**PB# 01-49**

**SUBJECT: SITE COMPLETION REVIEW - 7 Sept 05**  
**DeRIENZO SITE PLAN (Rt. 94)**  
**NEW WINDSOR P.B. APP. NO. 01-49**

**PROJECT NAME:** DeRIENZO SITE PLAN  
**PROJECT LOCATION:** 314 QUASSAICK AVE (RT. 94)  
SECTION 44 - BLOCK 1 - LOT 26 & 27  
**PROJECT NUMBER:** 01-49  
**DATE:** 26 SEPTEMBER 2001  
**DESCRIPTION:** THE APPLICATION PROPOSES THE CHANGE OF USE OF THE  
EXISTING BUILDING TO A PROFESSIONAL OFFICE. THE PLAN  
WAS PREVIOUSLY REVIEWED AT THE 25 JULY 2001 AND  
12 SEPTEMBER 2001 PLANNING BOARD MEETINGS.

**PROJECT NAME:** DeRIENZO SITE PLAN  
**PROJECT LOCATION:** 314 QUASSAICK AVE (RT. 94)  
SECTION 44 – BLOCK 1 – LOT 26 & 27  
**PROJECT NUMBER:** 01-49  
**DATE:** 25 JULY 2001  
**DESCRIPTION:** THE APPLICATION PROPOSES THE CHANGE OF USE OF THE  
EXISTING BUILDING TO A PROFESSIONAL OFFICE. THE PLAN  
WAS REVIEWED ON A CONCEPT BASIS ONLY

## PARKING LOT PAVEMENT DETAIL

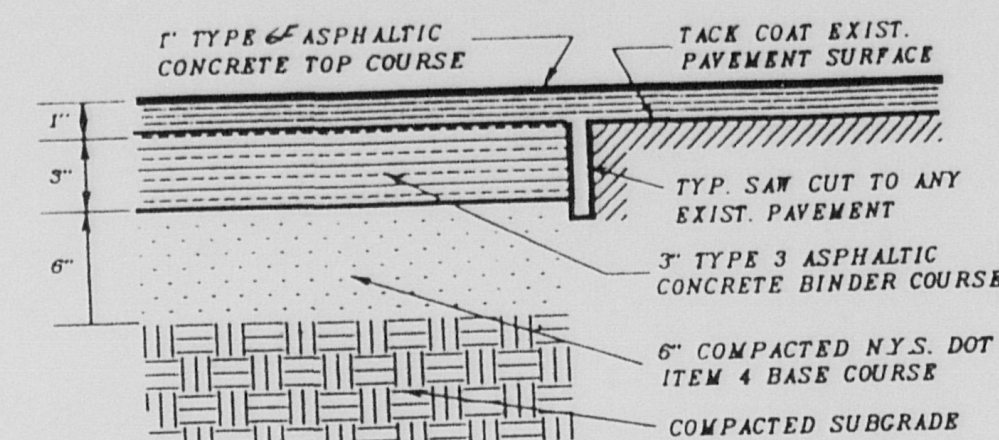
MR. PETRO: We also have the pavement details, should have the top course corrected to 6 and the handicapped detail requires--

1. My previous review noted several corrections needed. All corrections have been made, although two minor items need additional work, as follows:
  - The pavement detail should have the top course corrected to "6F".
  - The handicapped detail requires (based on a recent code change) and additional "No Parking" sign in front of the cross-hatched area.
2. As previously noted, I referred this application to the NYSDOT. The DOT responded by letter dated 8/30/01 and identified several corrections required to the plans. I am not aware of a subsequent approval from the DOT.
3. The Planning Board should require that a bond estimate be submitted for this Site Plan (Subdivision) in accordance with Chapter 19 of the Town Code.

## TREE PLANTING DETAIL

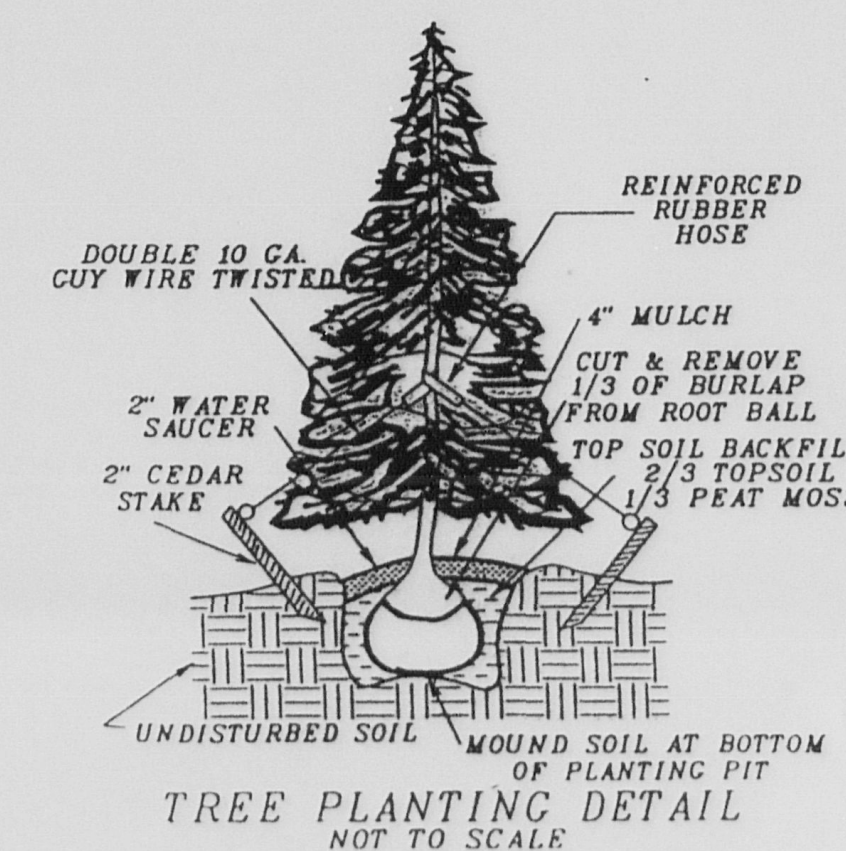
MR. PETRO: I think on the plan we should change the three foot to accommodate their concern to make that, I don't know about five foot, but close to five foot, why don't you make them five foot high, they have them there, I know they sell them that height. I think that five feet is the height of--

<u>Change trees to 5' high for screening</u>
<u>Need revised plans</u>
<u>Need D.O.T. Approval letter or Work Permit</u>

## HANDICAPPED PARKING SIGN DETAIL

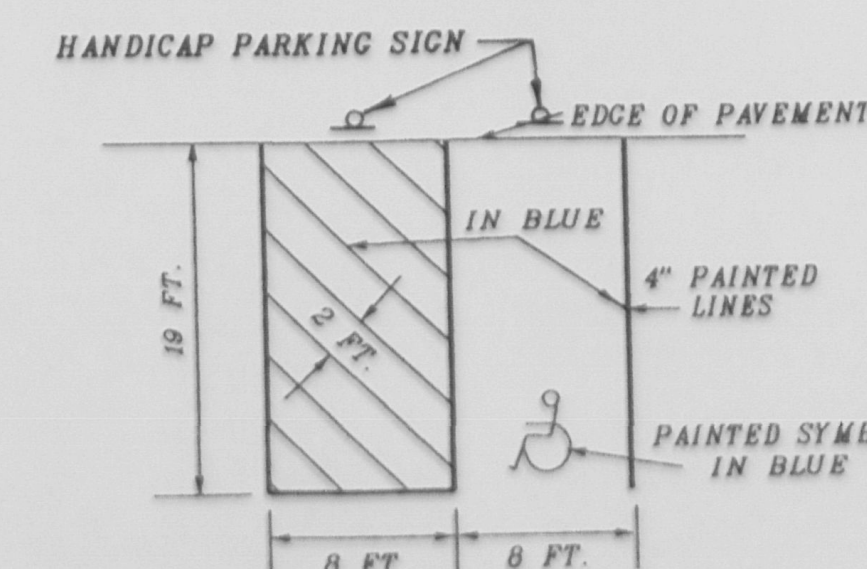
- b. Pursuant to a policy memorandum dated 23 February 1989 from the Town Building Inspector, a complete detail for the handicapped parking space and associated sign(s) should be provided on the plans.
